| Model: PE-P2/MF3 (P2 only) | Date: 12-Aug-11 | No.: RM096001e |

| Subject: Firmware Release Note: MAIN-PDL | | Prepared by: J.Kitagawa | |

| Model: PE-P2/MF3 (MF3 only) | | Date: 26-Jan-12 | No.: RM096007 |
| Subject: Damaged Leading Edge of Original | | Prepared by: H.K. | |

S mode settings

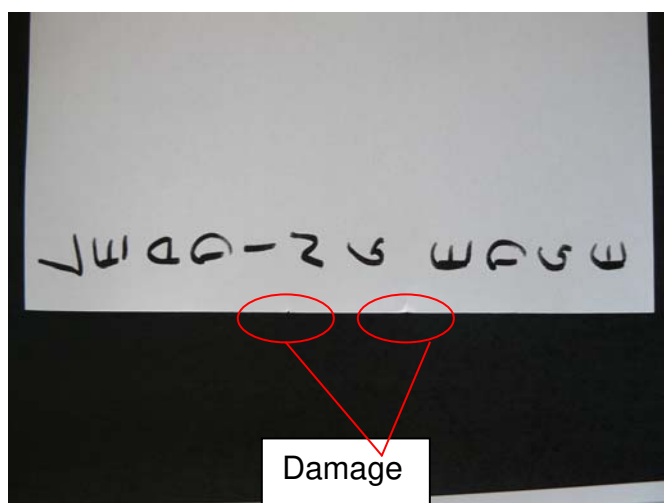
2. Change the following Special mode setting (inside Engine Maintenance mode) to prevent the paper from creasing.

0x10: Fusing idling mode, to be used when switching from Standard resolution to Fine resolution in the middle of continuous print jobs (ver1.03 or later)

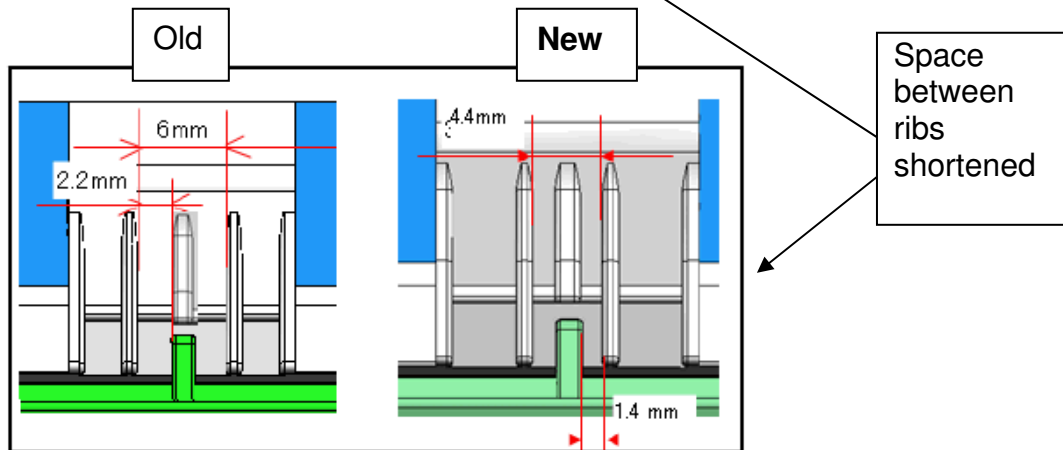
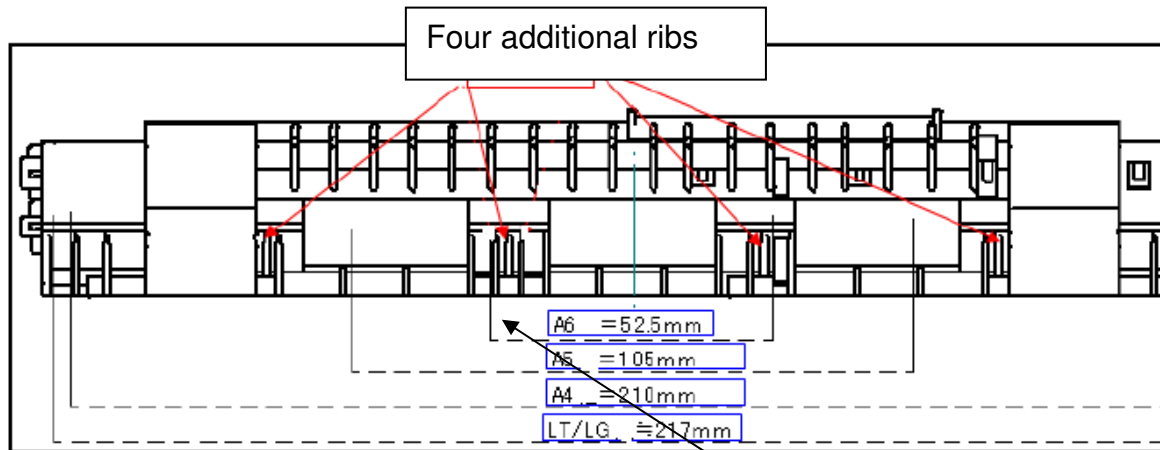
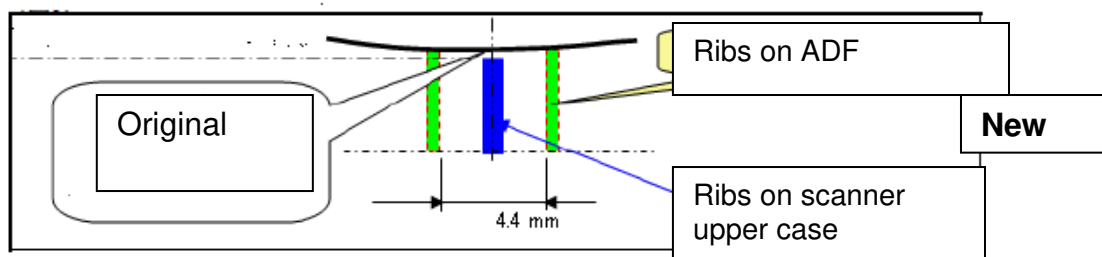
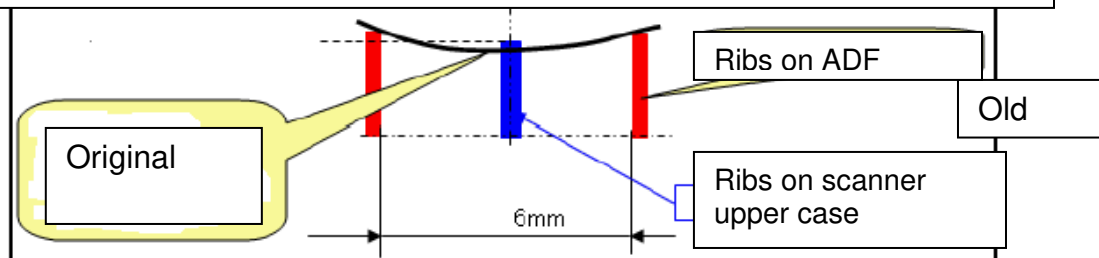
The leading edge of the original may sometimes be damaged when feeding from the ADF.

The leading edge sometimes touches the ribs on the scanner upper case.

- Four ribs were added to the "Guide:Feed:Driven".
- The height of the ribs on the ADF was increased by 1 mm.
- The space between the ribs was shortened.

Four ribs added to Guide:Feed:Driven

Height of ribs on ADF increased by 1 mm

Pinched harness

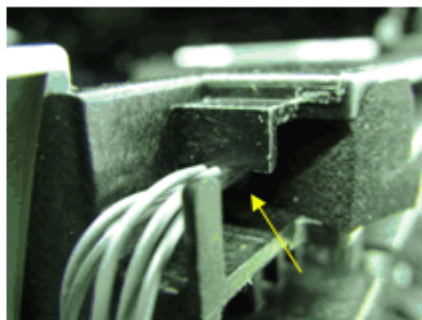
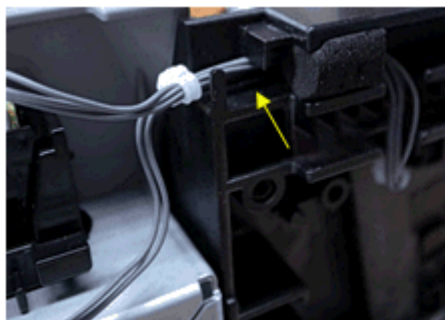
4. If the harness is pinched, but the cables inside are not cut or broken, wrap the affected area with insulating tape.
5. If any of the harness cables are cut or broken, or if the temporary taping solution in Step 4 is not effective, replace the harness so that it is not pinched.

6. Run/lead the harness as shown.

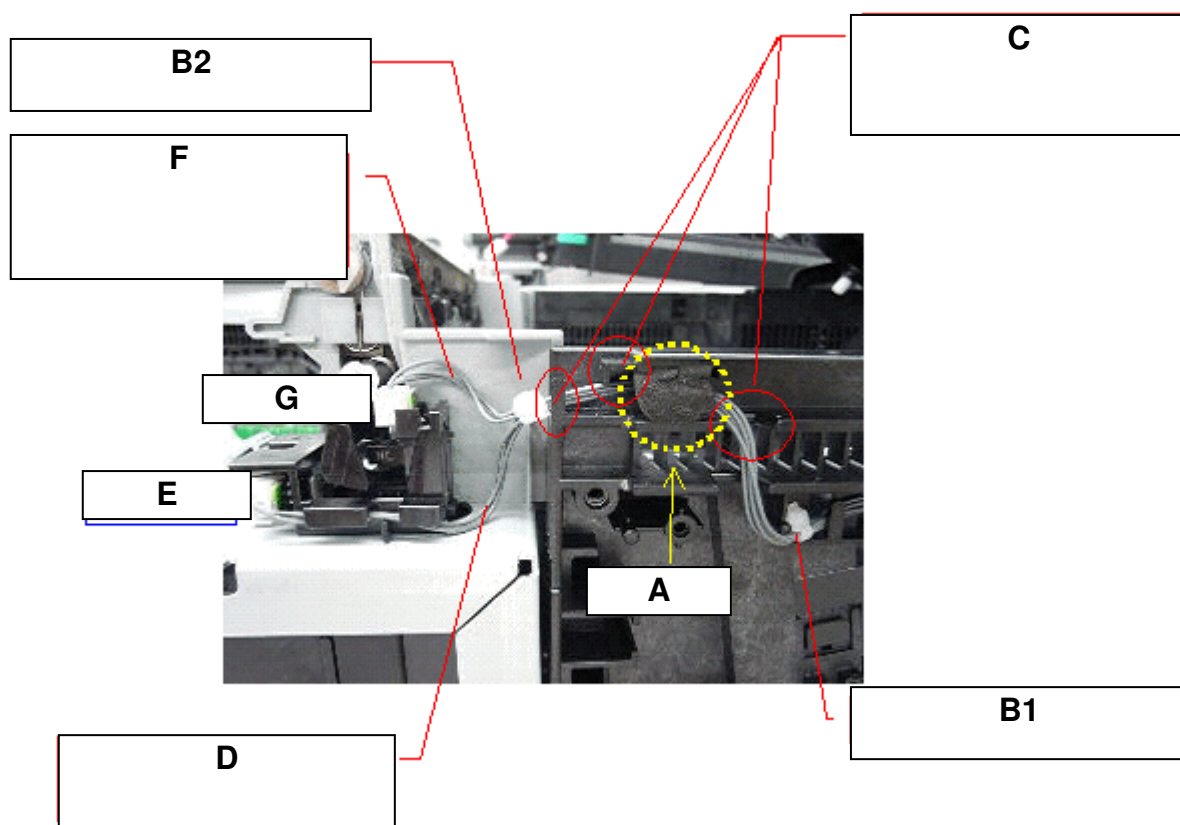
7. Make sure that **B1** and **B2** are in the positions shown in the photo below.
8. Push the sponge cushion [A] against the unit frame, so that the harness does not move outside the harness path [C].

9. If there is slack in the upper section of the harness [F] **more than** is shown in the photo, press the upper section [F] (for fusing pressure release sensor [G]) down, so that it does not rise above the level shown in the photo.

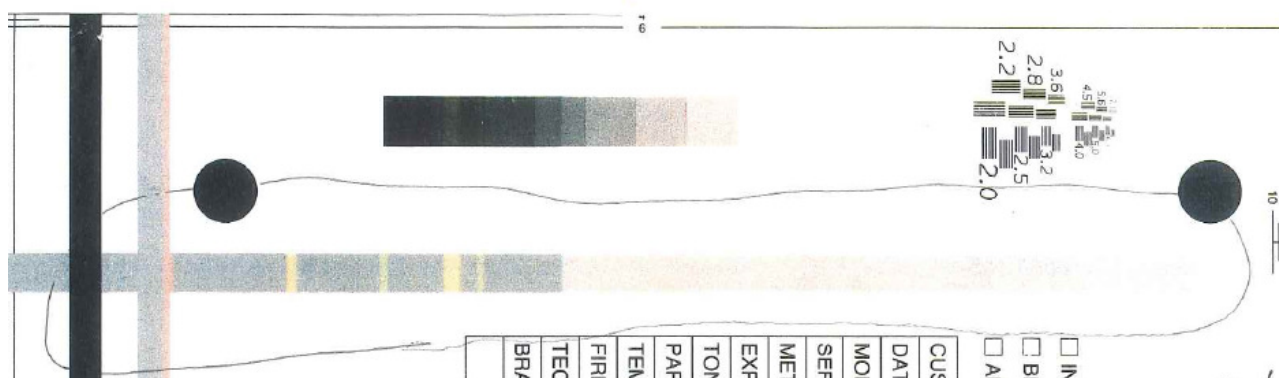
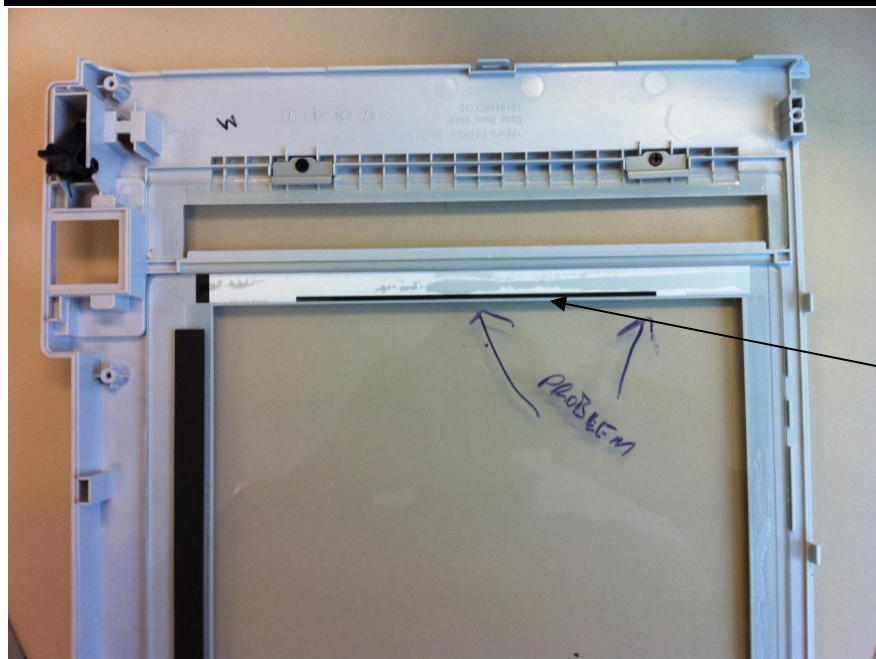
White or colored stripes may appear on copies.

The glue that fixes the calibration white plate to the edge of the exposure glass melts. As a result, it leaks out and is picked up by the scanner.

1. The following were added to the production process from September 25, 2011.
 - No cleaning solvents (including pure alcohol) are used to clean the shading sheet, exposure glass, and upper scanner case.
 - A visual check is performed to make sure that glue cannot be seen between the exposure glass and white plate, after the glue has dried.
2. A new type of glue is used to attach the white plate. This glue will not melt in high-temperature, high-humidity conditions, nor by cleaning solvents.

1. If the symptom occurs, replace the upper scanner case or scanner unit.
2. To prevent occurrences, do the following:

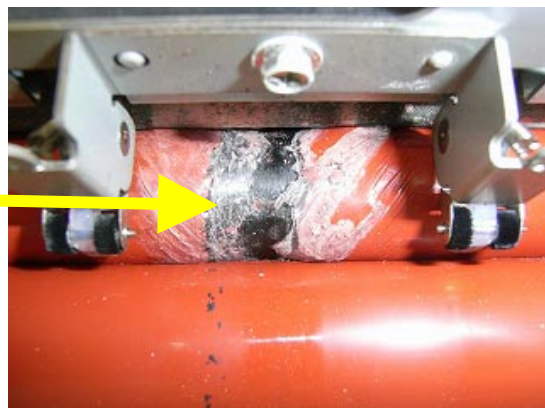
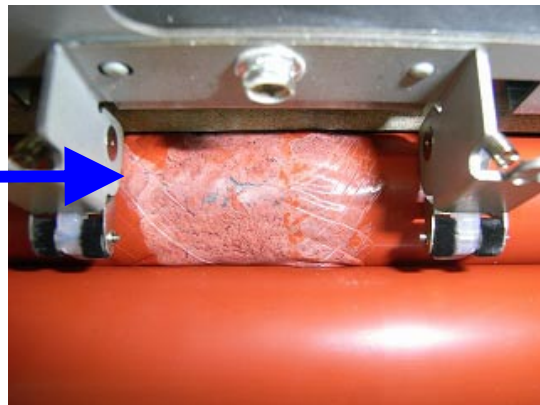
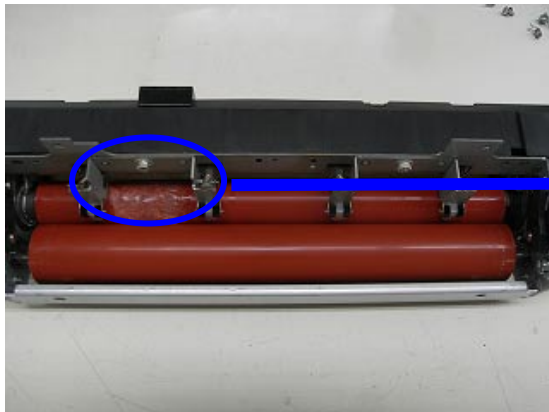
One or more of the following occur at 50-100mm from the center of the hot roller (right side, left side, or both):

- Creases develop in the tube around the hot roller
- The hot roller's rubber layer separates from the metallic core
- The tube and rubber layer are damaged

1. Replace the fusing unit.
2. Update the **Engine** firmware to **v1.05** or later.

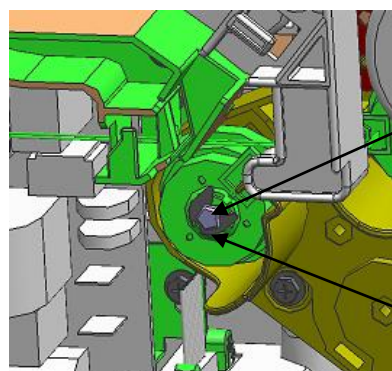
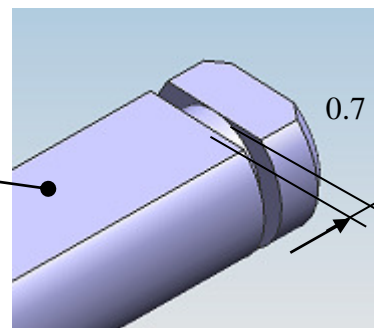
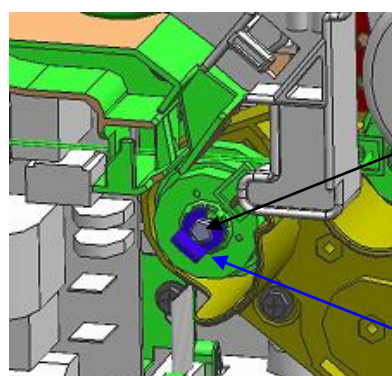
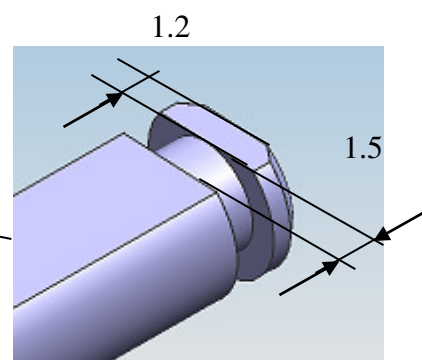
- 1) The width of the e-ring groove in the paper feed roller shaft was increased.
- 2) The e-ring was changed to a C-ring.

Reason: To facilitate assembly.

08050089 → H5213355
